INITIAL FIRE SAFETY INSPECTION REPORT

Youngone (CEPZ) Limited (Extension 2)

RSC ID: 26361

Date: 22-July-2025

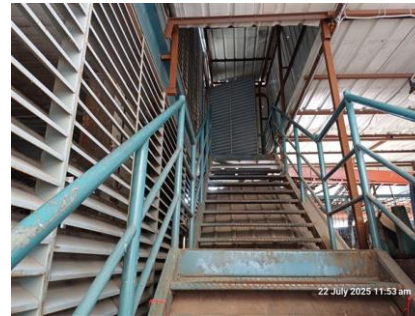
F-04	Means of Egress	<p>Unsealed penetrations and openings are located in exit stair enclosures due to cable penetrations.</p> <p>Location(s): Stair-3, and 4 at Ground Floor of YCL-5 Building.</p>	<p>No other penetration into and through the exit enclosure except for fire alarm equipment electrical raceway, required exit doors, sprinkler piping, standpipes, and electrical conduit serving the exit enclosure is permitted in accordance with section 6.14.4 of RSC Technical Guidelines (Standard)¹ V1.0. So, relocate the electrical wires/raceways to somewhere else avoiding the exit enclosure, and seal the created unprotected openings with a minimum of 1.5 hours listed/certified fire-rated materials. Installation shall be as per manufacturer published installation guideline and the certification authority guideline to ensure the fire-rating. Or seal the penetration by 2-hr masonry construction.</p>	Within 3 Months

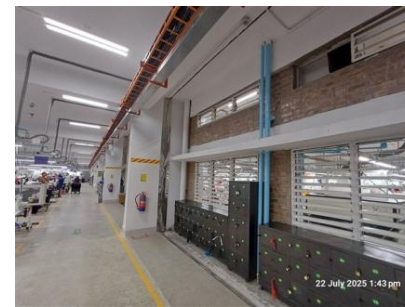
F-11	Fire Rated Construction	<p>Elevator shafts open directly into the exit enclosure, which doesn't comply with RSC Technical Guidelines (Standard), section 6.14.3.</p> <p>Location(s): YCL-5, Exit Stair-1.</p>	<p>Provide a minimum 2-hr fire rated elevator shaft to separate it from stair enclosure. No discharge is accepted through elevator shaft. Seal all openings to maintain fire separations.</p>	Within 3 Months
------	-------------------------	---	---	-----------------

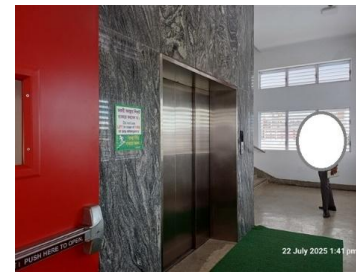
F-12	Fire Rated Construction	<p>Elevator shafts open directly into the production floor without proper fire separation due to unprotected opening.</p> <p>Location(s): YCL-5 Building.</p>	<p>Elevator shaft shall be separated from production area by 2 hours fire rated construction. 2-hr fire barriers shall be protected with minimum 1.5-hr fire protective opening assemblies.</p>	Within 3 Months
------	-------------------------	---	---	-----------------
